Re: Turkey Point Units 3 & 4
Docket Nos. 50-250 & 50-251 P
Portable Demineralizer

In response to your letter of September 15, 1978, we are submitting the attached information to supplement our letter of June 4, 1976 which was made to meet the requirements of Section V.B of Appendix I to 10 CFR 50.

Re: Turkey Point Units 3 & 4
Docket Nos. 50-250 & 50-251
Portable Demineralizer

FIGURE 4.1

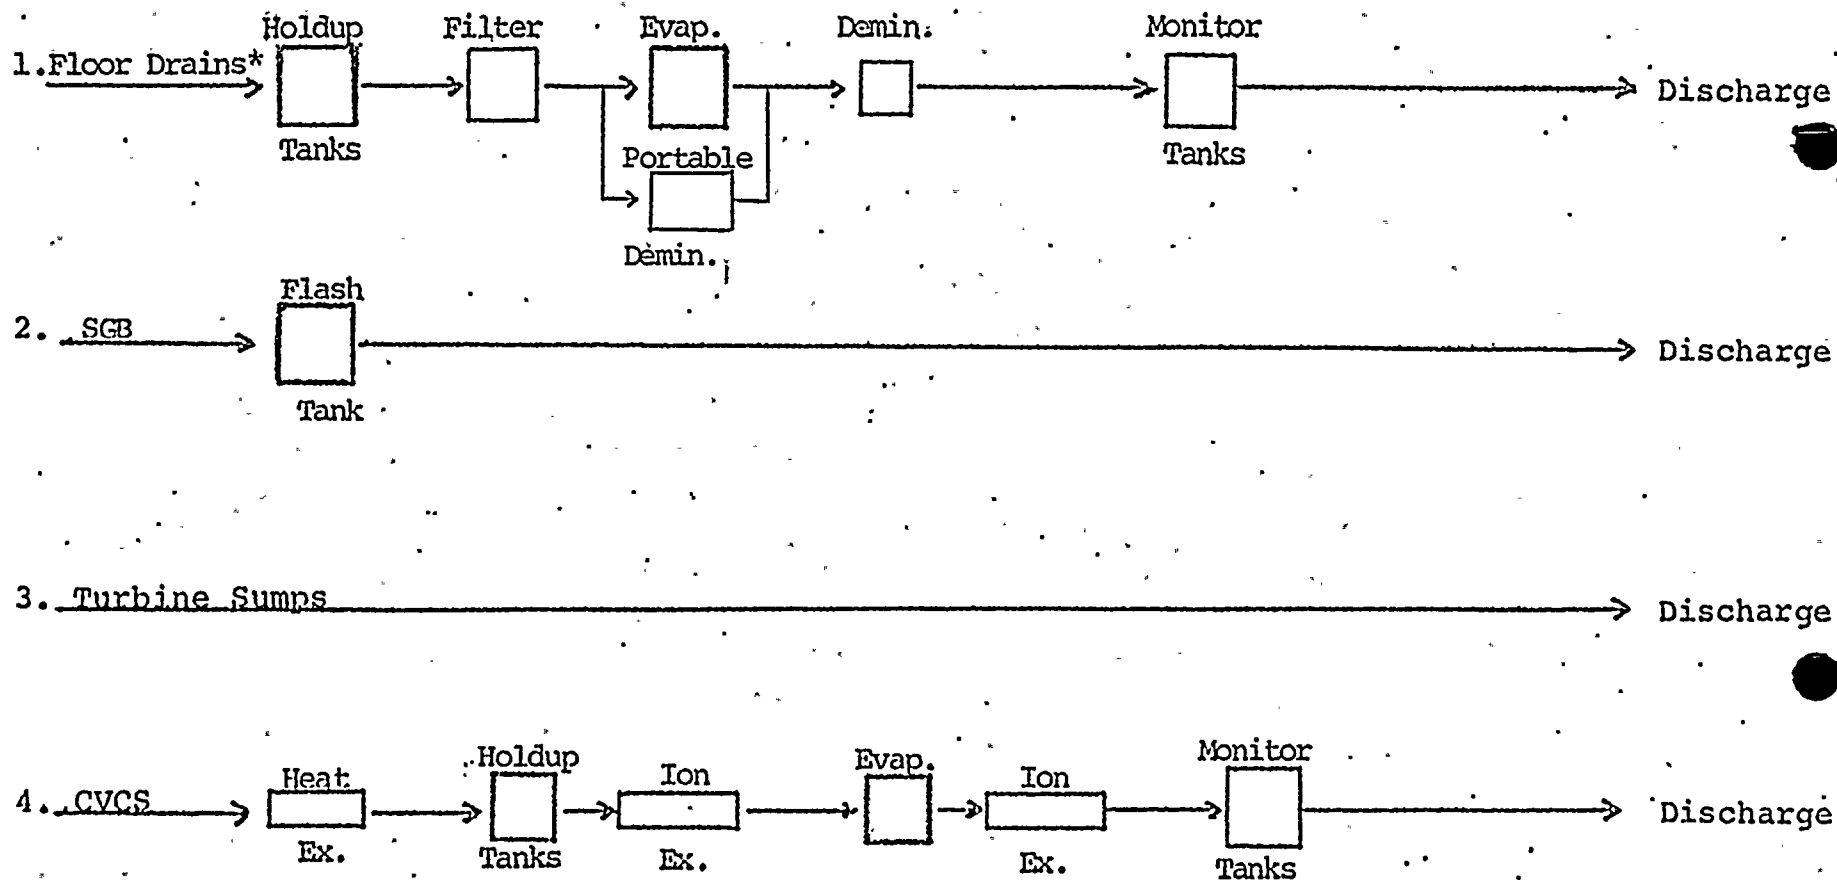
For the purpose of operational evaluation, the floor drain treatment system has been supplemented by a portable demineralizer. Evaporation is still used periodically. Figure 4.1 (page 55) of FPL's letter of June 4, 1976 should be revised as shown on the attached figure.
